P/20/2380/2 - Outline application for up to 150 dwellings, together with new open space, landscaping and drainage infrastructure, with all matters reserved except for access (as amended to include proposed junction improvement works at Barkby Road Crossroads received 20/05/22) Barkby Road Queniborough

Queniborough Parish Council wish to comment further on this application, in addition to the comments already submitted on 29th April 2021, 12th August 2021 and 20th October 2021.

Stage 1 Road Safety Audit

Arboricultural Report

Appendix B – Problem Location Plan

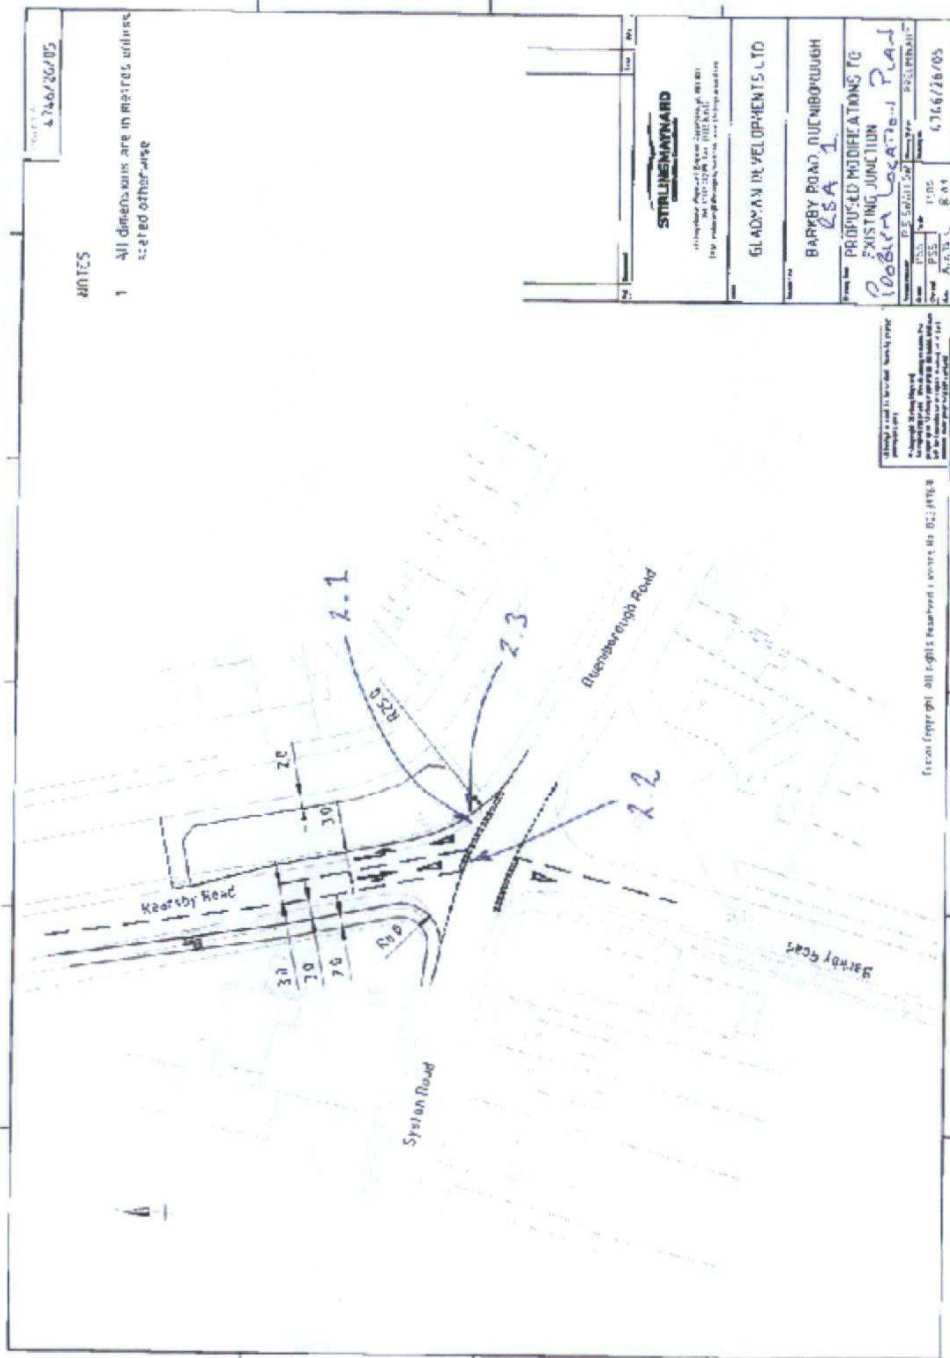
Location: Rearsby Road Approach

Summary: Risk of collision between left turning vehicles and eastbound vehicles on Syston Road

The proposed layout for the Rearsby Road approach to the junction indicates a dedicated left turn only lane and a combined straight ahead and right turn lane. The audit team consider that there a number of safety issues associated with this proposed layout, including:

- The angle of a left turning vehicle at the give-way line is such that a driver's view to the west could be compromised by the vehicle structure or could require the driver to twist in their seat to observe oncoming vehicles. As a result an approaching vehicle, in particular a motorcycle or cycle, could be masked from view resulting in the left turning vehicle emerging into the path of the oncoming vehicle.
- The above situation could be further compromised if a vehicle, in particular a larger vehicle, is waiting to proceed in the straight ahead/right turn lane as this could potentially further mask approaching vehicles.

Location: Straight ahead vehicle movements

Summary: Risk of collision with vehicles in the left turn lane or vehicles waiting to turn right from Barkby Road

The proposed layout of the Rearsby Road approach indicates a combined straight ahead and right turn lane. However, a vehicle wishing to travel straight ahead into Barkby Road would be required to take a minor left/right stagger movement across the junction. This may result in

them being in collision with either adjacent left turning vehicles or vehicles waiting to turn right from Barkby Road.

Location: Re-aligned footway

Summary: The proposed footway arrangements may increase the risk of inappropriate pedestrian crossing movements across the mouth of the junction.

The proposed design requires that the existing footway on the east side of Rearsby Road is incorporated into the carriageway to provide the indicated left turn lane. To accommodate pedestrian movements it is indicated that a new section of footway would be provided on the western side of the parallel service road. This would link to the existing controlled pedestrian crossing on Rearsby Road to the north of the junction. As a result of the increased walking distance that this would entail, the risk of pedestrians walking along the north side of Syston Road choosing to cross Rearsby Road at the junction may be increased. As a result the risk of collisions between pedestrians and vehicles may be increased. As the width of the carriageway is also increased this may further increase the risk of collision between pedestrians and vehicles.

Retain the existing angle of waiting at the give-way for left turning vehicles.

Retain the existing alignment for vehicles wishing to travel south towards Barkby.

Retain a footway on the east side of Rearsby Road.
